**AGENDA ITEM SUMMARY / STAFF REPORT**  
**FLORENCE PLANNING COMMISSION**

**ITEM TITLE:** PC 21 29 SUB 02 – *Stonefield Investments Tentative Plan with Mods*

**(Proposed) CITY OF FLORENCE  
PLANNING COMMISSION**

**FINDINGS OF FACT (Proposed)  
FLORENCE PLANNING COMMISSION  
EXHIBIT A**

PROFILES  
 Sheet title:  
**C4.0**

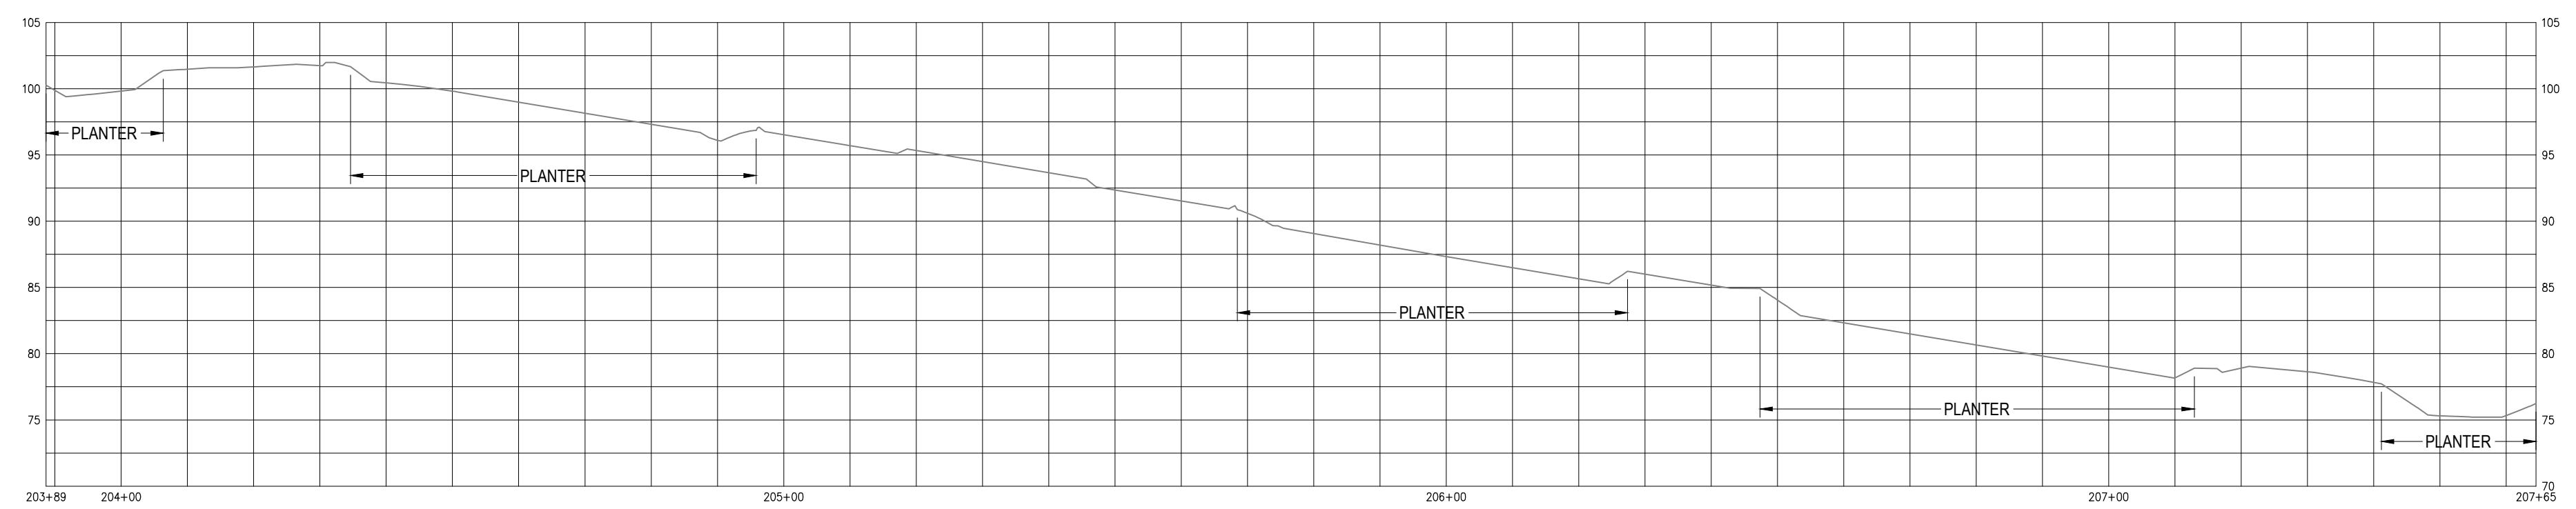
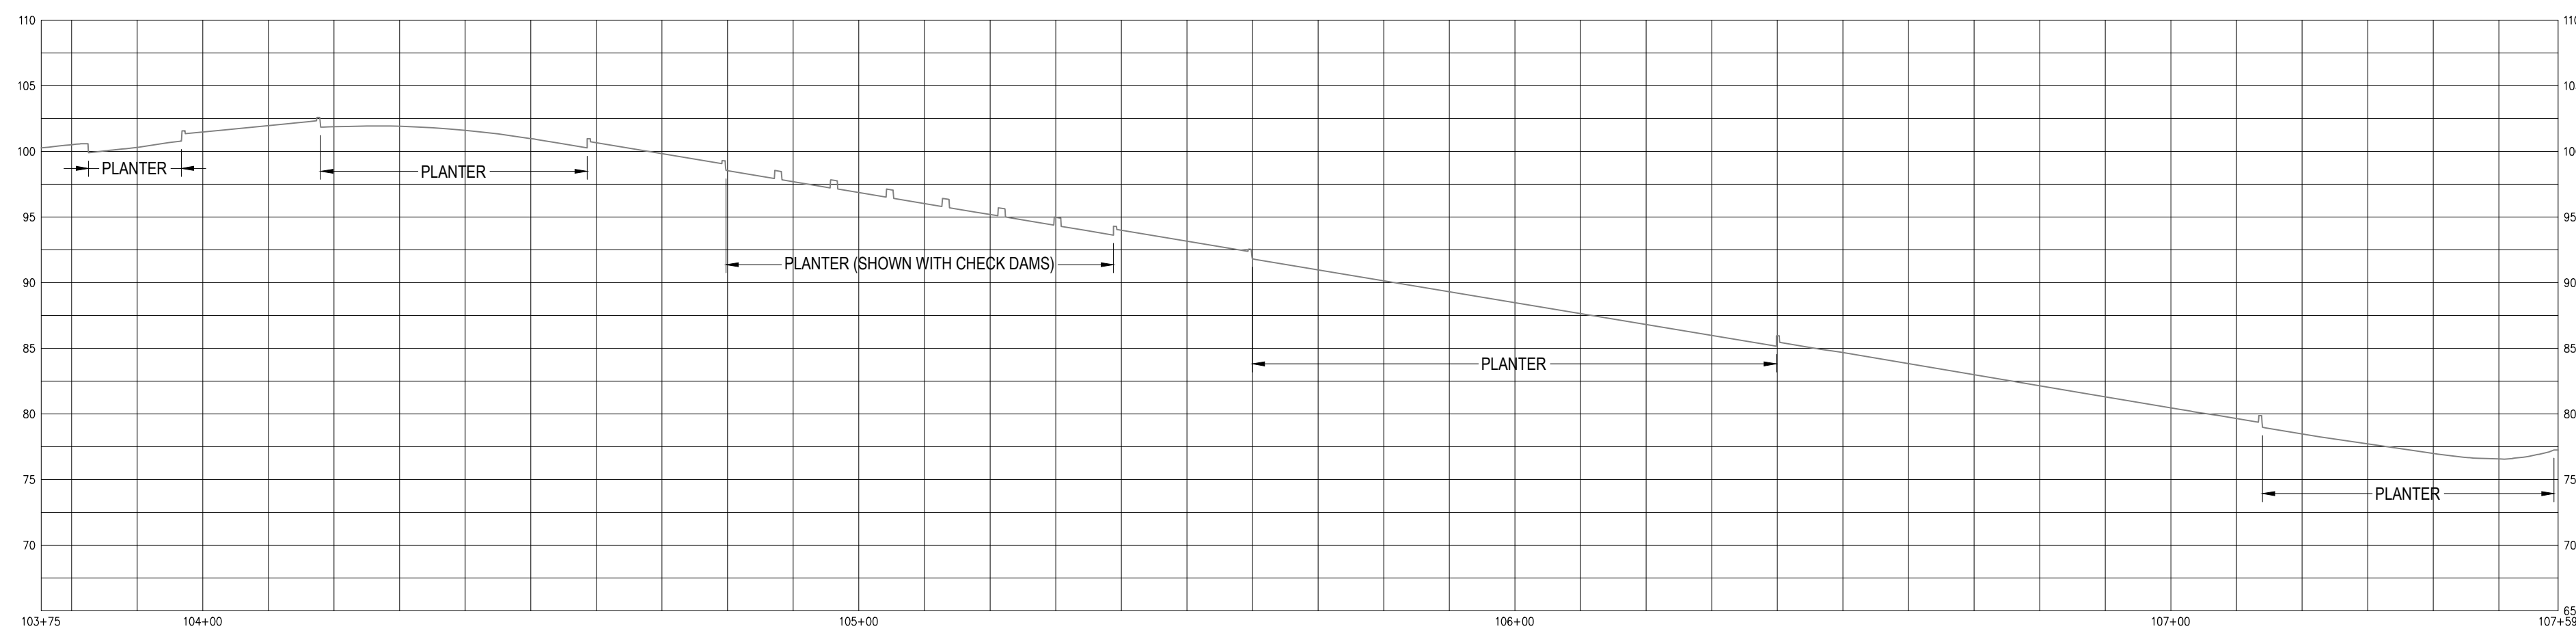
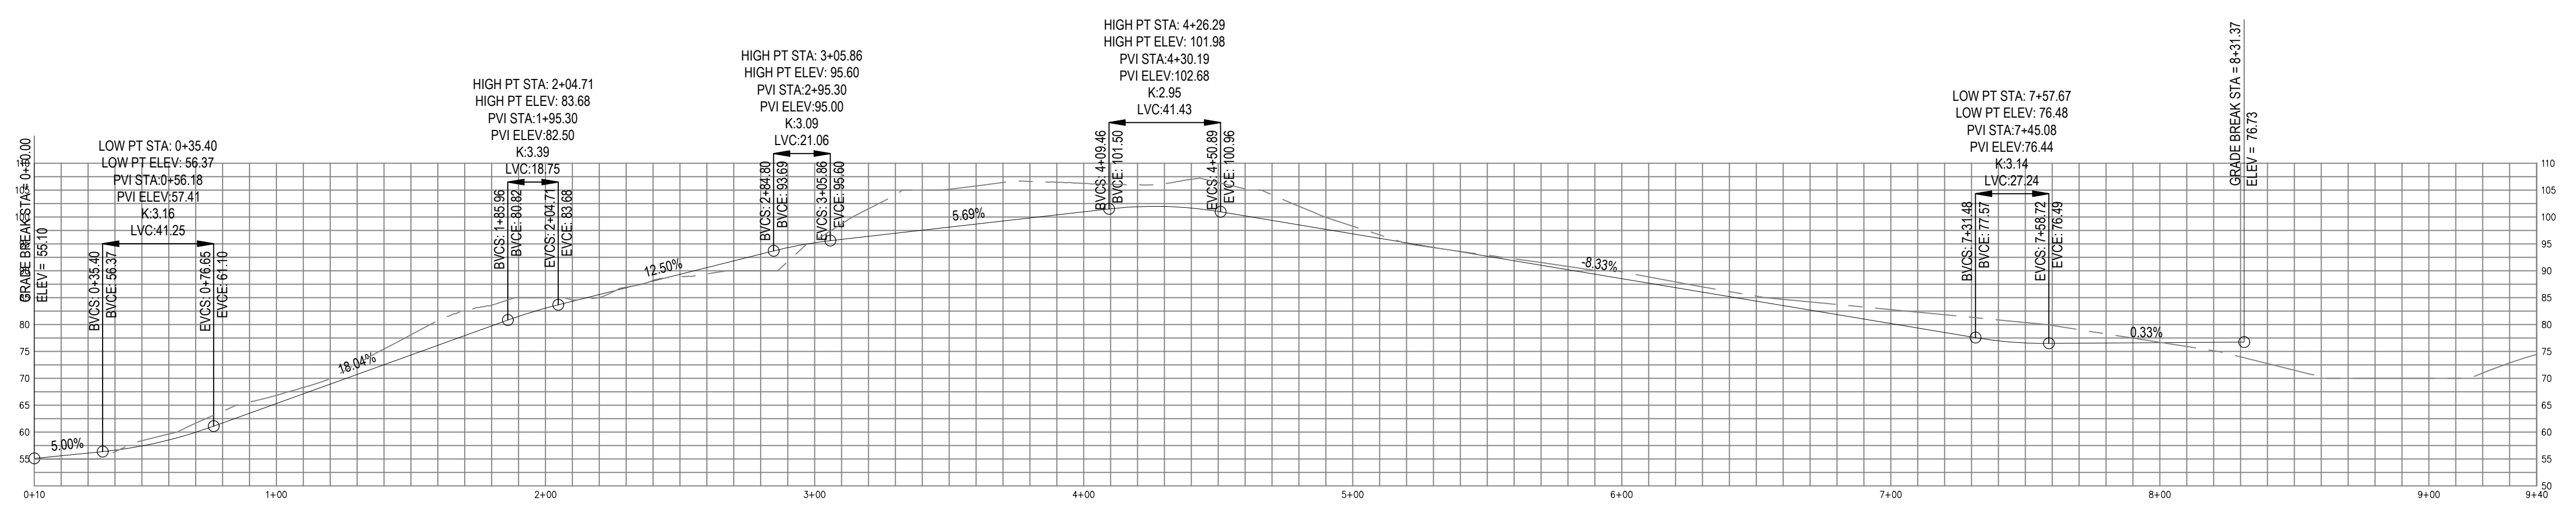
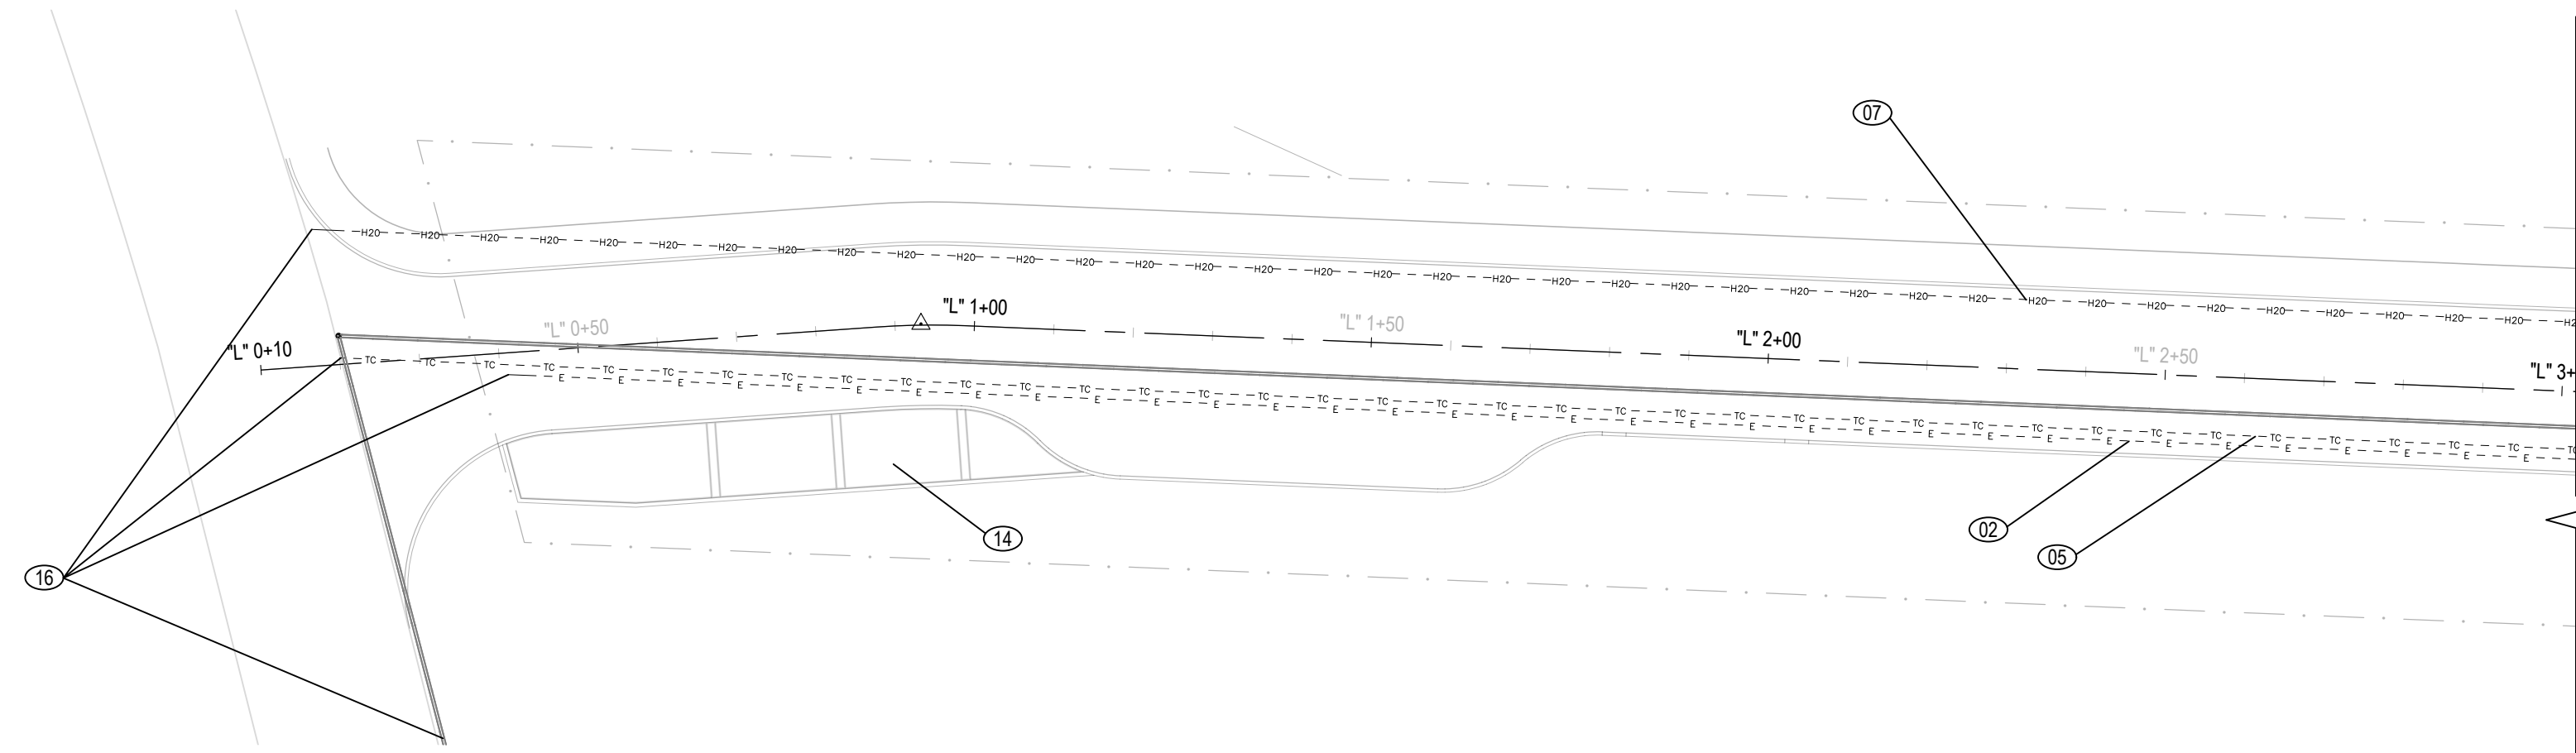
FINDING: The grade and road profile of the proposed street to serve the subdivision, is seen on Sheet C4.0 (Exhibit C). The applicant has revised the grade of the street from 18 percent down to 12 percent, in order to comply with FCC 10-36-2-15. The radius of the cul-de-sac to be at the end of the street is shown on Sheet C2.0, Exhibit C1.

The proposal substantially complies with the platting and mapping standards (FCC 11-5) as shown on the supporting documents. The maximum street grade of 18% shown on Sheet C4 has been adjusted to 12% to comply with FCC 10-36-2-15 and will be reflected on the final plans. The following exceptions require an Application for Modification to FCC 11-5-1 Streets in accordance with FCC 11-7;

UTILITY PLAN  
Sheet title:  
C5.0

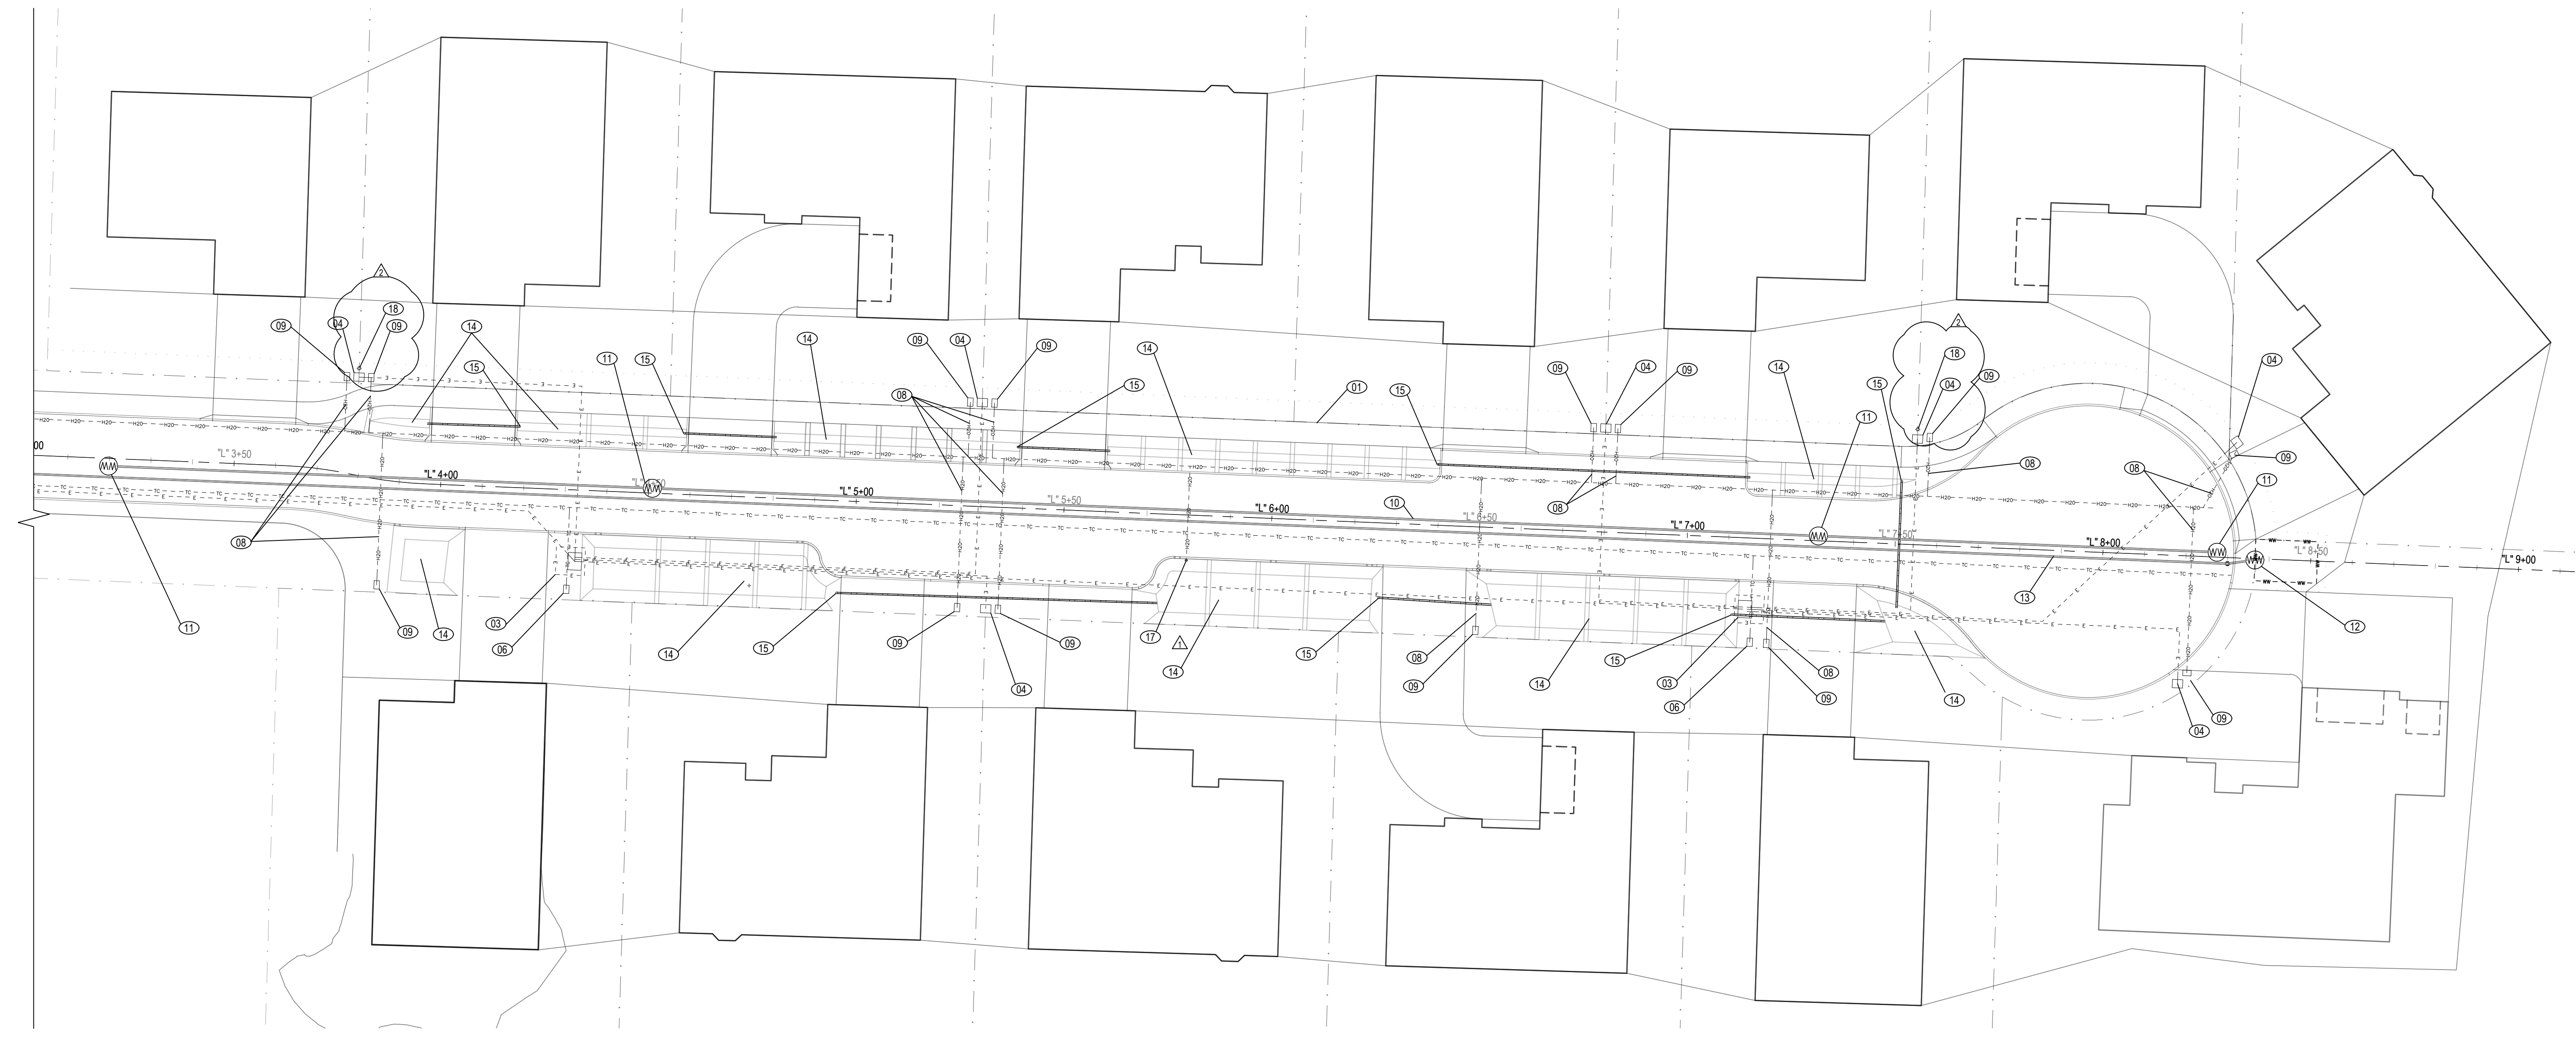
*“Siuslaw Valley Fire & Rescue is requesting more detail (no fire hydrants noted in utility plans) on the number of fire hydrants and locations of fire hydrants within the subdivision.”*

- *It's difficult to get a whole lot out of the utility plan without more information, but it looks like everything should work properly. The wastewater appears to consist of a gravity system that will then connect to a private pump station that conveys out to the City's low pressure force main. It appears that there is adequate clearance between utilities. The planters and corresponding overflow pipes will need to be constructed per City of Florence Stormwater Standards. A blowoff may be required for the significant high point that will occur in both the water main and the sewer force main."*

FINDING: As seen on the revised Utility Plan (Exhibit D, Sheet 5.0), the applicant is proposing to provide one fire hydrant (seen as Keyed Note #17). For compliance with FCC 10-36-3-E, prior to the issuance of building permits, the applicant shall provide verification of existing and proposed water service mains and hydrant flow supporting the site. Fire flow analyses and plans for hydrants and water service mains shall be subject to review and approval by the Building Official or Fire Marshal. **(Condition 8).**

8. As seen on the revised Utility Plan (Exhibit C2, Sheet 5.0), the applicant is proposing to provide one fire hydrant (seen as Keyed Note #17). For compliance with FCC 10-36-3-E, prior to the issuance of building permits, the applicant shall provide verification of existing and proposed water service mains and hydrant flow supporting the site. Fire flow analyses and plans for hydrants and water service mains shall be subject to review and approval by the Building Official or Fire Marshal.

- 14.** A 5' wide Public Utility Easement (PUE) is shown on the Tentative plan on Revised Sheet C5 of Exhibit C2 north of the proposed right-of-way/sidewalk. The same 5' wide easement is illustrated on the properties in the revised C2. On parcels 8 and 9 there are 21' wide and 12' wide utility easements. No other easements are seen on the Tentative plan. Prior to final plat approval, the approximate width and location of all reserve strips (if indicated) and all existing and proposed easements for public utilities shall be shown on the final plat, consistent with the platting standards of ORS 92.

FINDING: The proposed water supply is from Heceta Water District. The preliminary utility (Revised Sheet C5.0, Exhibit C2) plan submitted with the accompanying Tentative plan shows the locations of a 6" PVC water line, water lateral line, and water meter boxes (seen as Keyed Notes 07, 08, and 09 on Sheet C5.0). All engineering water service plans will have to first be reviewed and approved by the Public Works Director or their designee, before the issuance of building permits. It is feasible for the applicant to provide domestic water to the proposed subdivision.
